Consumers
POWER
Company

MIDLAND PROJECT -
ALAB-106 MONTHLY REPORT FOR JULY 1980
DOCKET NOS 50-329 AND 50-330
FILE: 0.4.6 UFI: 70*01 SERIAL: 8816

LOG OF NONCONFORMANCE REPORTS

PLAN @ 674'-6"

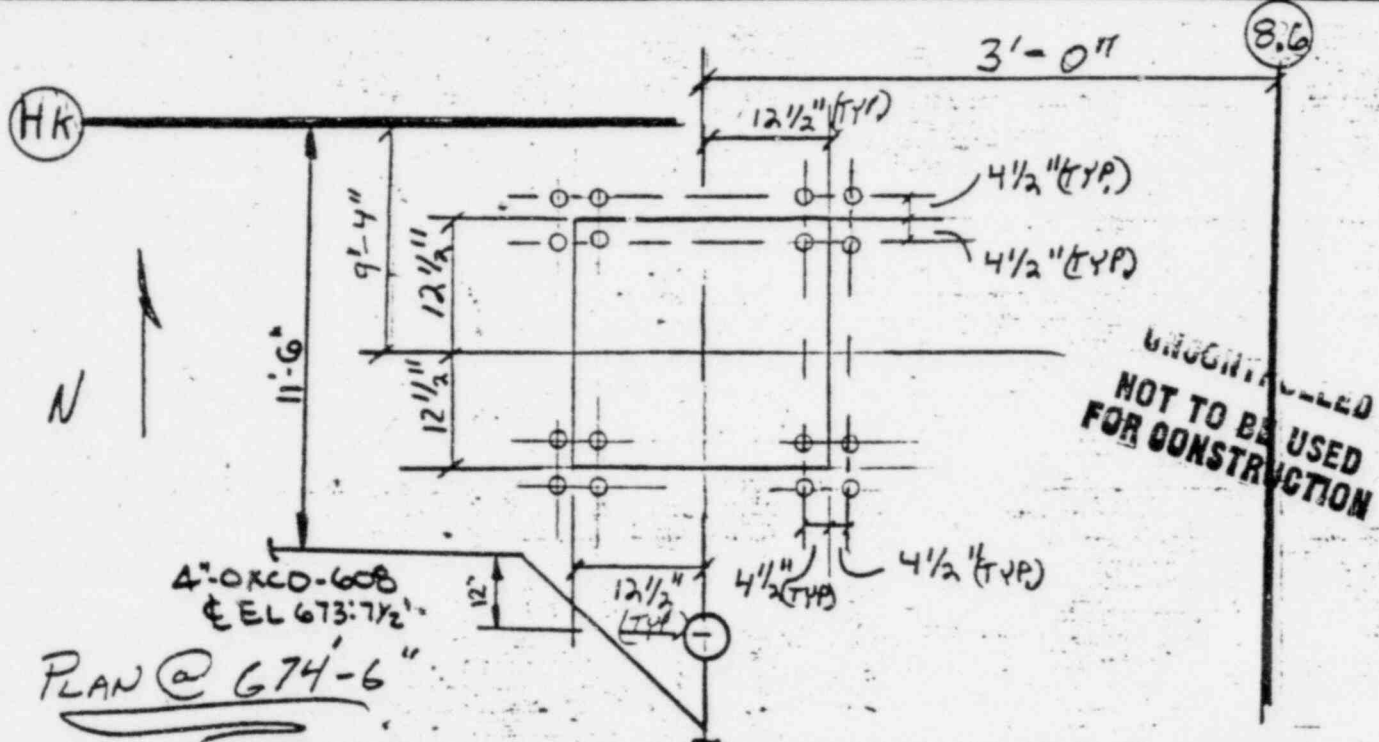
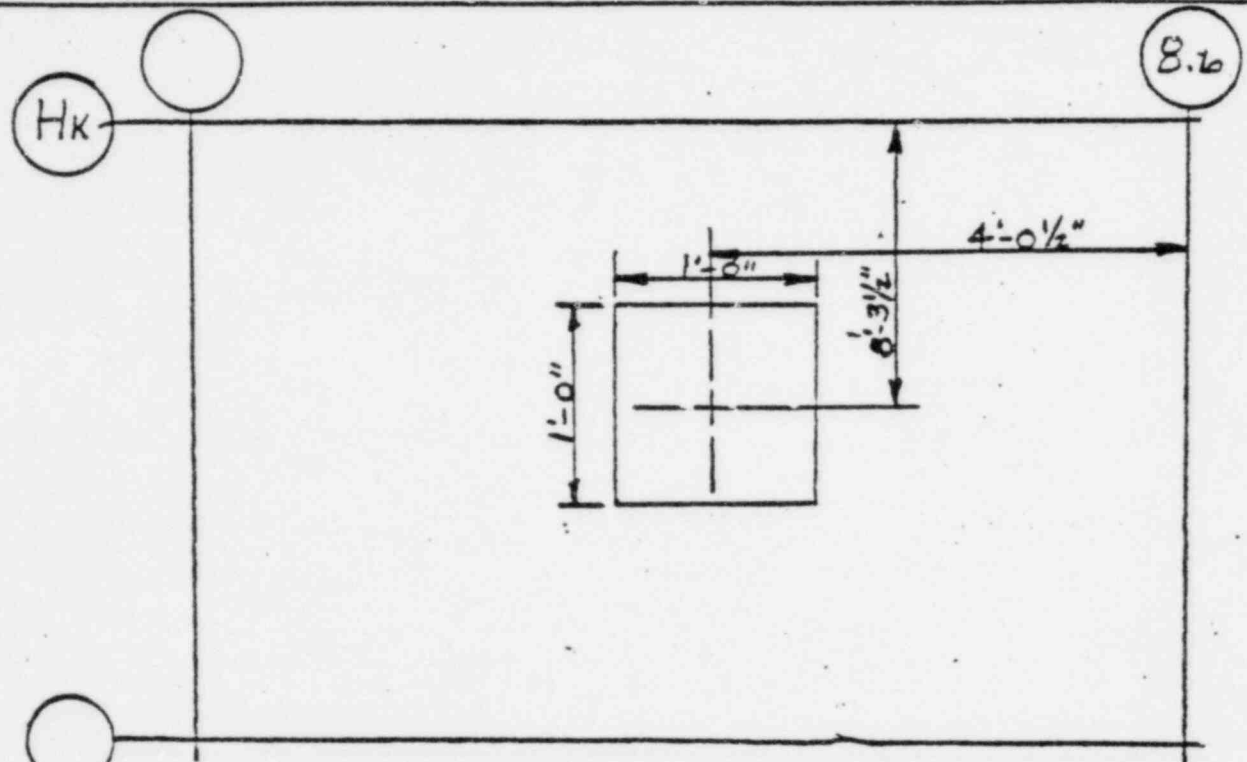
16. Nonconforming Condition: Conduit 2BE013, 4" G.R.S., embedded in Floor of Purge Rm # 703, elev 674'6", above location, has been core drilled. See concrete Drilling Permit # 6458 (Sheet # 2). Concrete has been chipped out in the vicinity of the damaged conduit. See Concrete Drilling Permit # 6861 (Sheet # 3). Dist. 3.006 Hold Fire engineering disposition Date 7-1-80 Validated By [Signature] TO FIELD ENGINEERING <input checked="" type="checkbox"/> TO OTHERS (SPECIFY) <input type="checkbox"/>

4" GRS CONDUIT. PENETRATION DIRECTLY SOUTH OF AREA SHOWN, MAY BE UTILIZED.
 Loads per drawing C-2050: (list only for attachments to Q-Listed blockwalls or poured walls substituted for Q-Listed blockwalls)

PLAN - FAN SUPPORT - CIV-08

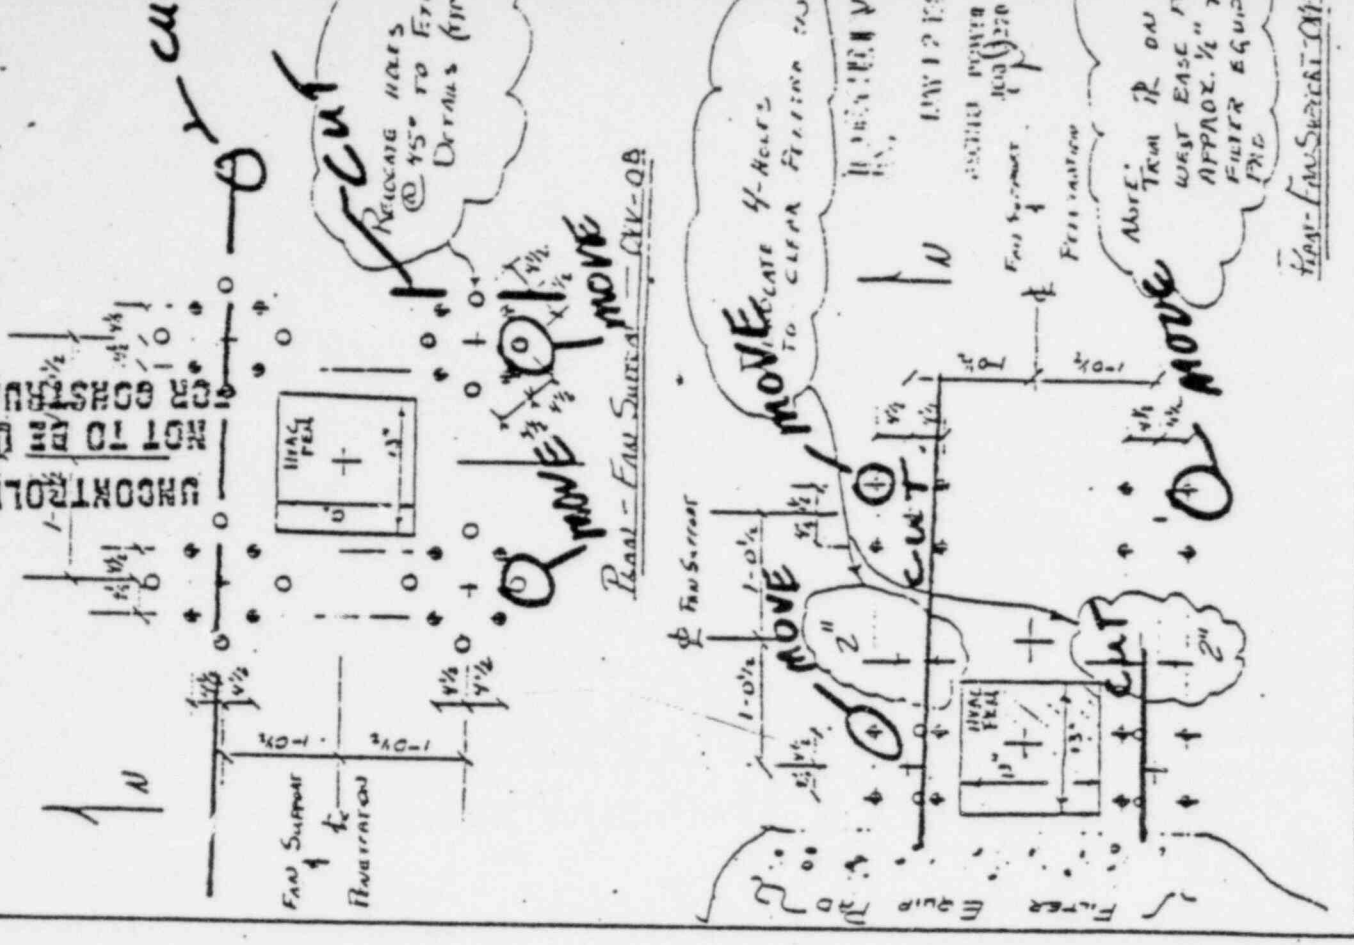
REASON FOR CHANGE: ALEXANDER BELTS CAN SAFELY BE CUT OR AVOIDED ARE LOCATED TOO CLOSE TO AVAL. PENETRATIONS

DESCRIPTION OF CHANGE: FIELD REQUEST TO RELOCATE HVAC ANCHOR BOLTS TO THE NEW LOCATION AS SHOWN.

APPROVED: YES NO
 PROJECT NUMBER: [Blank]
 SIGNATURE AND DATE: [Signature] 4/22/80
 REMARKS: DWG Change required. See drawings 1150

DWG. M-617 SH.2 (A) REV. 4
REACTOR BLDG UNIT 2

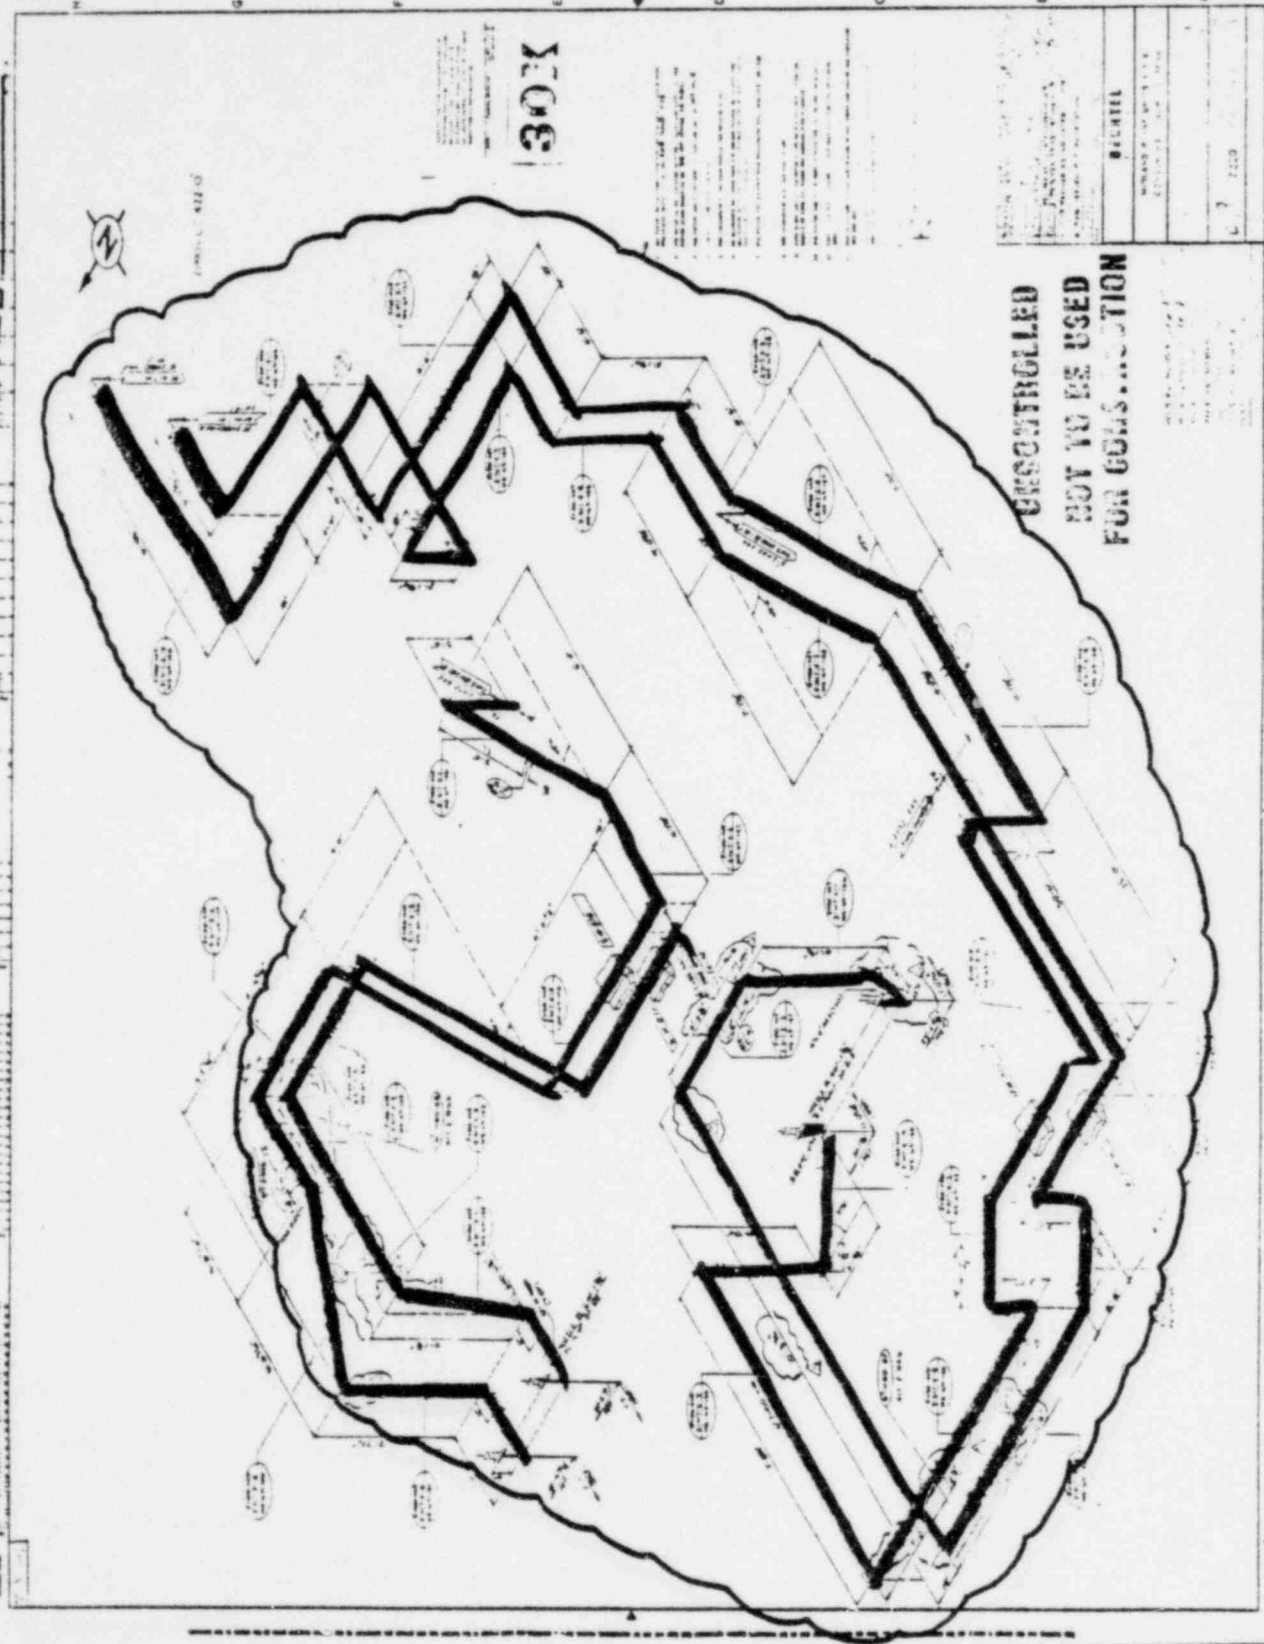
Inse Shop coating. Hold for Engineering Disposition. Q-number is indeterminate.
No hold tags applied.

Elevation View Looking South

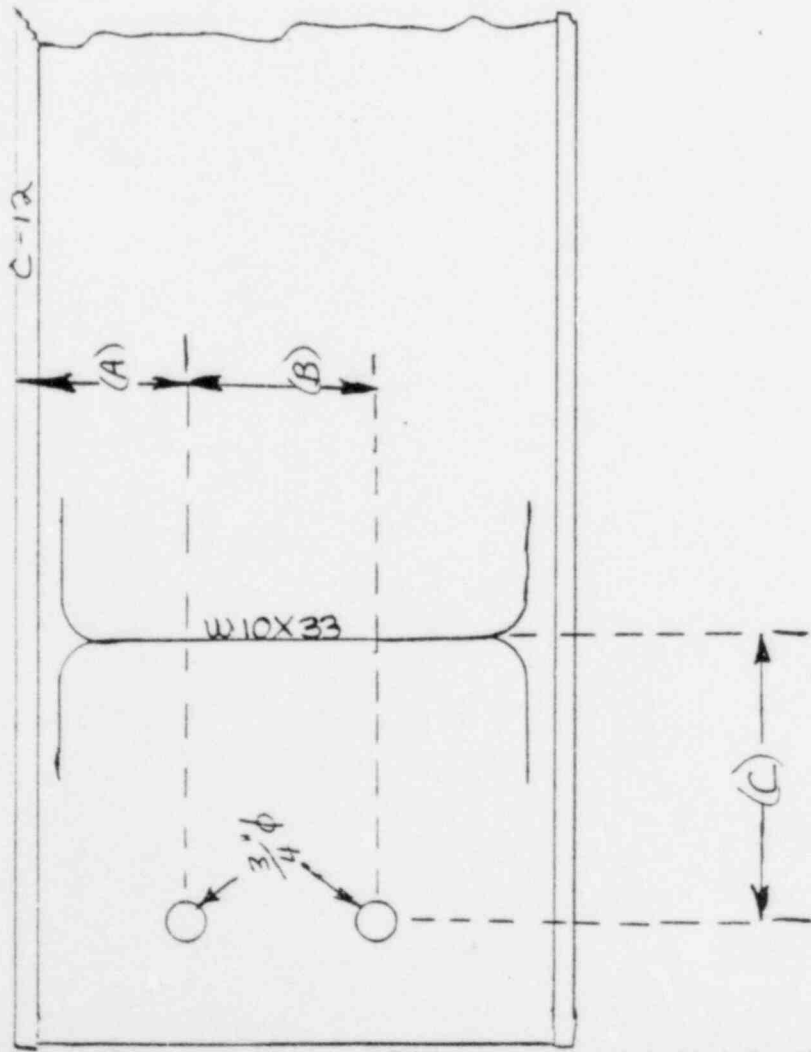
anchor. No vertical tolerance is given. Contrary to this, the spacing has been reduced, as shown on attached sketch. Bays #2 & 4

- ③ Section C and Dwg. C-1004 calls for (4) $\frac{5}{8}$ " expansion anchors, attaching clip angles to the concrete wall. Contrary to this, in one instance, an unapproved detail has been utilized to weld one clip angle to an embedded channel, as shown on attached sketch. $\frac{5}{8}$ " anchors @ 3" centers were used for the other clip angle at this location. The remaining connections, in Bay #3 per Section C, are also at 3" centers. (See disposition of NCR 2970)

Block 23 - Redisposition of Item #1

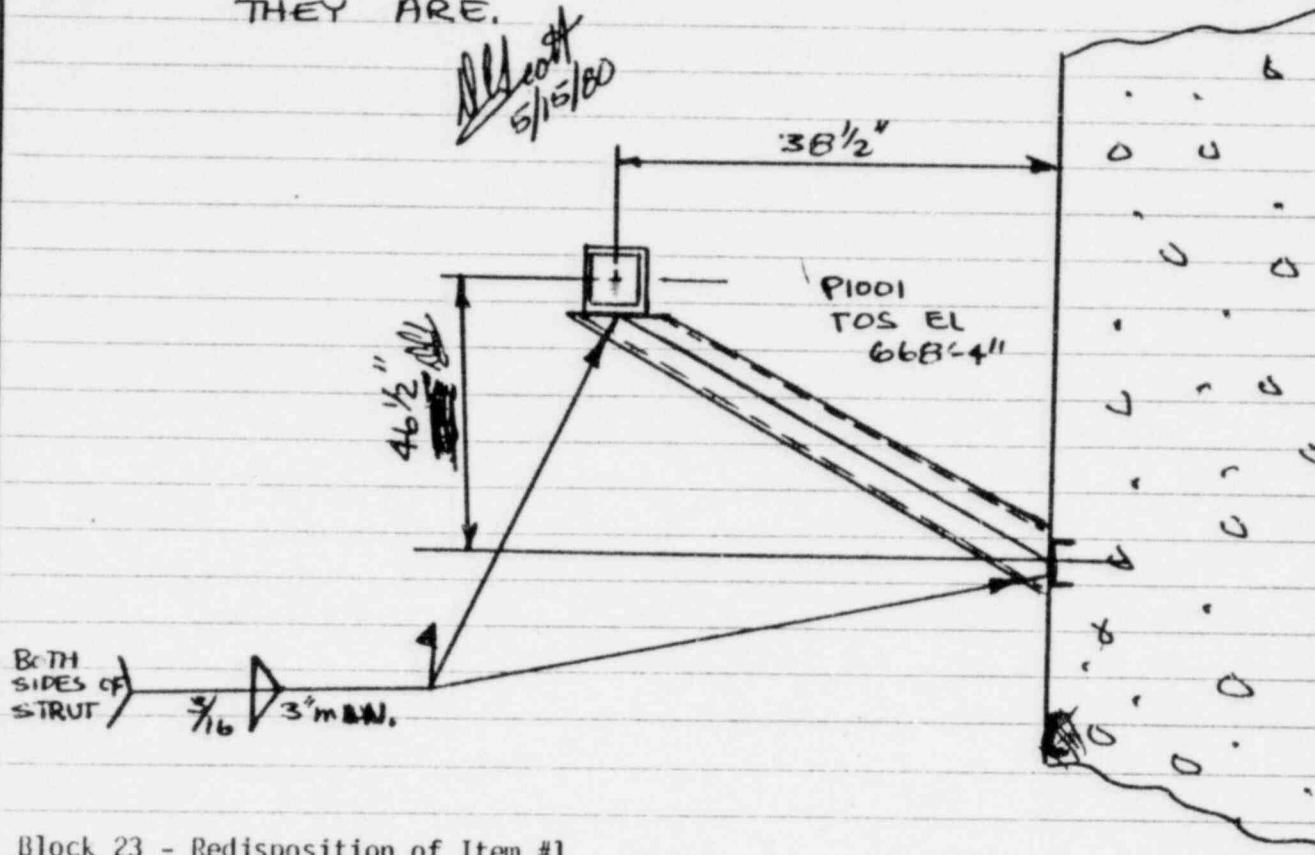
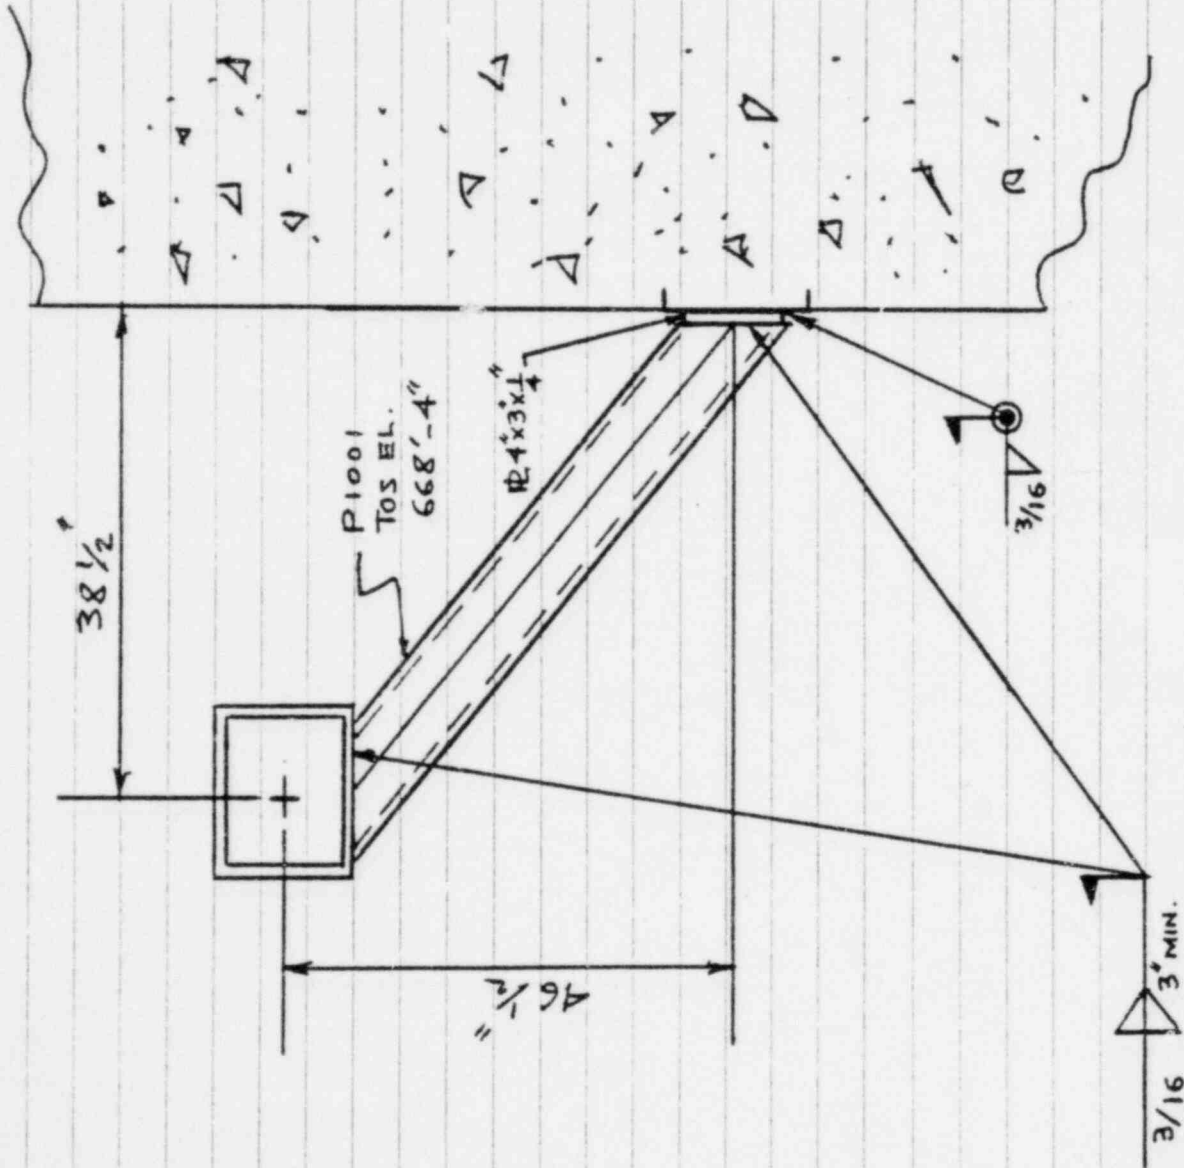
BLOCK 22) REDISPOSITION ITEM 1, THE BOTTOM TWO ~~ANCH~~ ANCHORS CAN NOT BE REMOVED. AFTER DISCUSSING THE PROBLEM WITH A RESIDENT CIVIL ENGINEER IT WAS DETERMINED THAT A POSSIBLE ALTERNATIVE WOULD BE TO ADD A HORIZONTAL BRACE AS SHOWN BELOW AND LEAVE THE TWO BOTTOM ANCHORS AS THEY ARE.

Project Engineering has reviewed the Field Engineering Redisposition of Item 1 and has determined that the addition of the brace will allow two anchor bolts to adequately support the shear loads involved, therefore, the non-conforming condition shall be repaired in accordance with sketch on page 6 of NCR. REM C-2722

Drawing E644(0) Sh. 1 will be revised.

PLAN @ 674'-6"

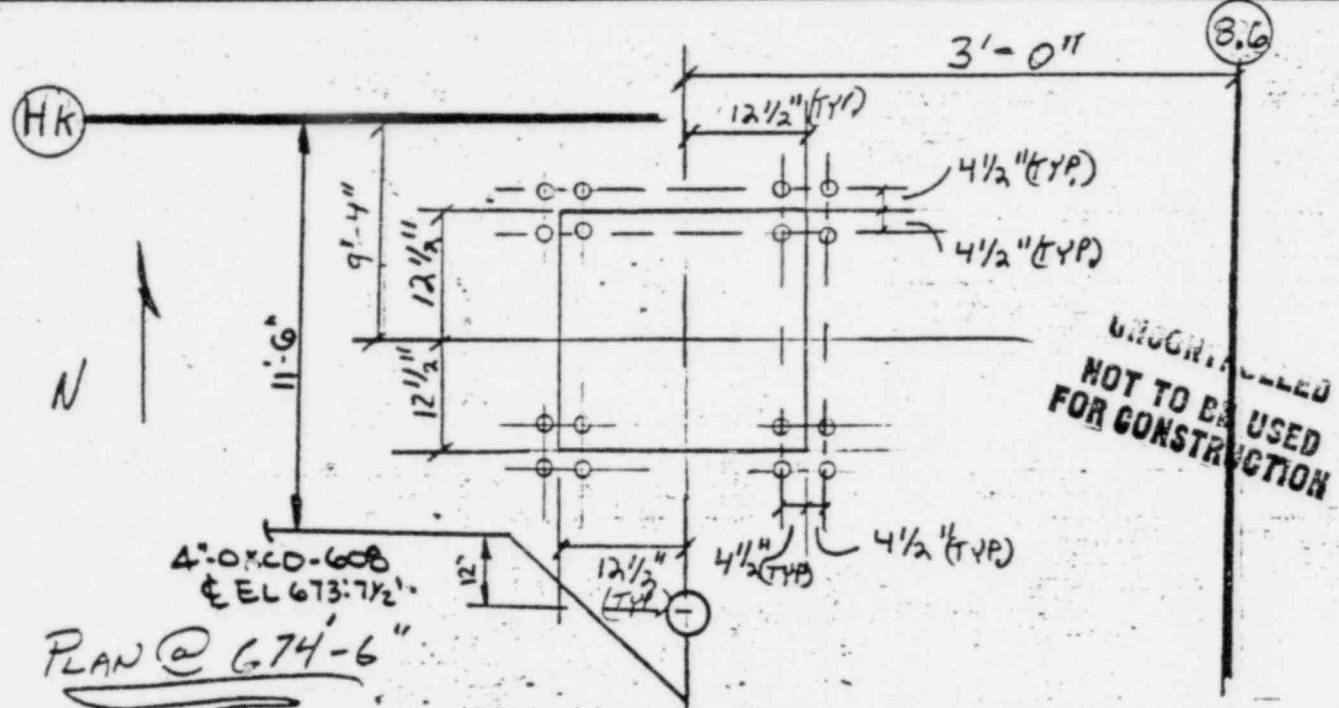
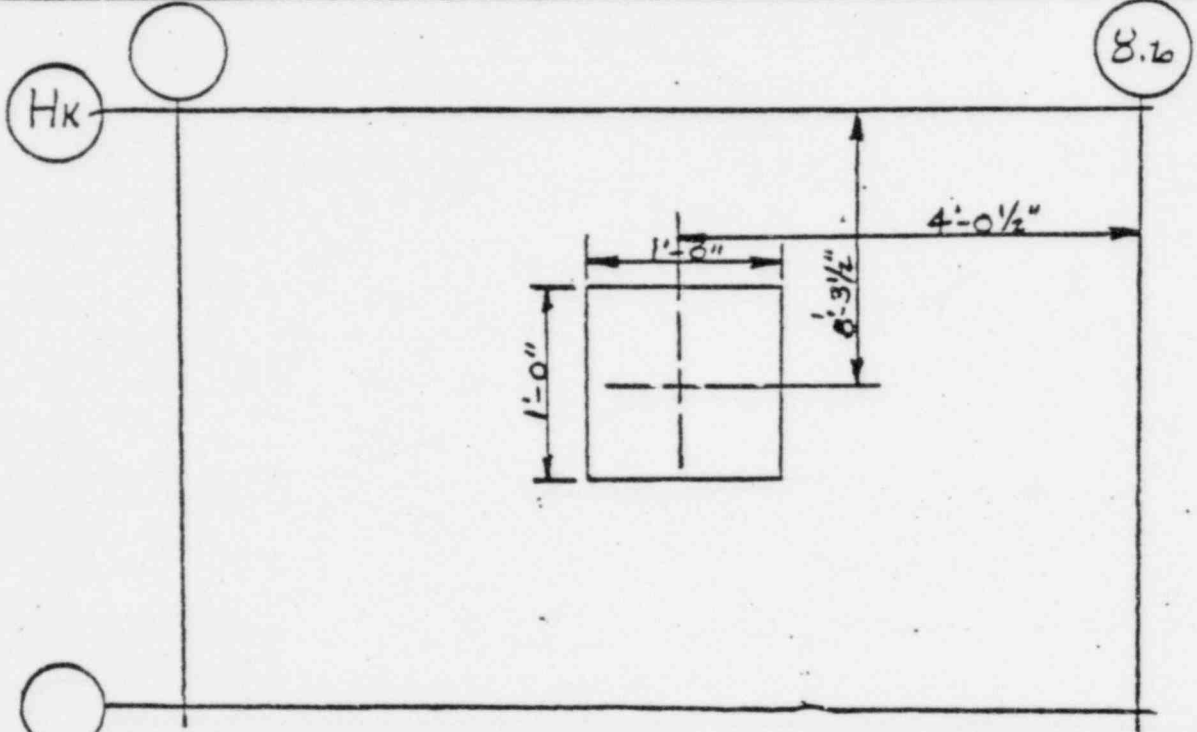
4" GRS CONDUIT. PENETRATION DIRECTLY SOUTH OF AREA SHOWN, MAY BE UTILIZED.
Loads per drawing C-2050: (list only for attachments to Q-Listed blockwalls or poured walls substituted for Q-Listed blockwalls)

22. <input checked="" type="checkbox"/> Field Engineering Disposition <input type="checkbox"/> Field Engineering Recommended Disposition to Project Engineering					
Drill permit # 7022 has been issued, in accordance with REMC-2543, D. Sheet 7/17/80
